**From:** Maria Calderon  
**Sent:** 20 September 2021 09:53  
**To:** Megan O'Mara  
**Subject:** Beck Hole Bridge

**BECK HOLE BRIDGE, GOATHLAND, SCARBOROUGH, NORTH YORKSHIRE  
Application No. NYM/2021/0263/LB**

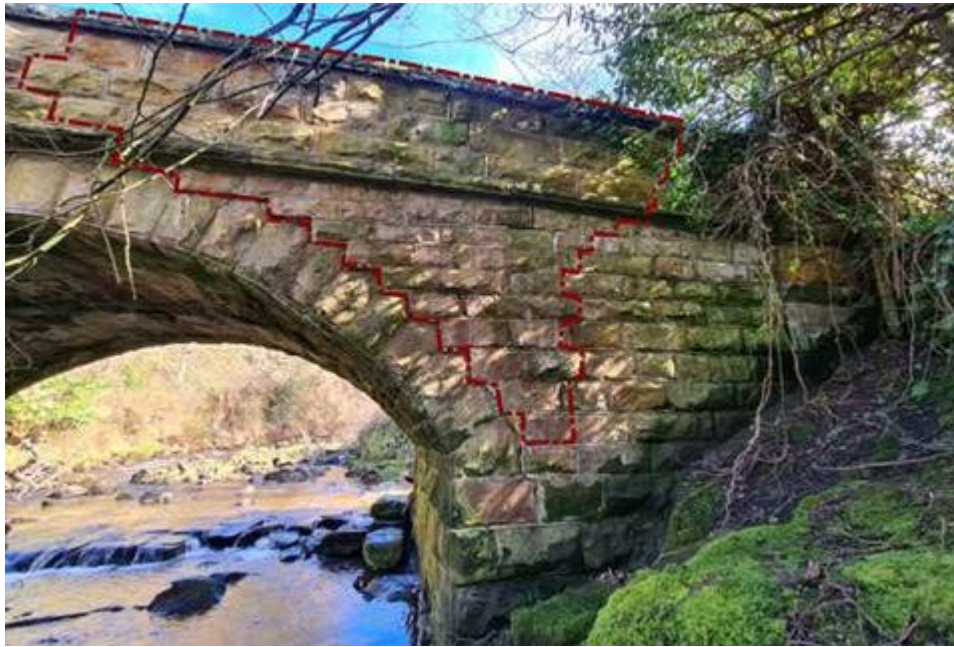
- However, the supporting drawing conflicts with the DAS/HS in scope: the extent of the proposed dountaking is about double that which is actually suffering from structural

activity (see below).

- The photographic evidence suggests the lateral translation of the spandrel relative to the barrel peters out and terminates around springing level at the lower end, and does not reach the crown at the higher level. For practical stability reasons, the masonry will need to be opened up to a splayed / corbelled profile to access the affected area, but even accounting for this the scope in my view is about twice that which seems to be required. I can see no justification for the rebuilding of the upper part of the end pilaster. Further, taking down the masonry beneath springer block will open up a can of temporary support worms which should be borne in mind, I wouldn't do this unless expressly required.

- A more focused scope of repairs based on the photos is outlined below, which I think the project should be tapered back to. The proposed intervention doesn't in my view actually deal with the problem: if the spandrel is too thin to resist the lateral earth pressure, then it should be thickened to the rear (i.e. dig down the back of it and substantially increase its thickness – possibly combined with some fixing into the extrados if this is not toothed).
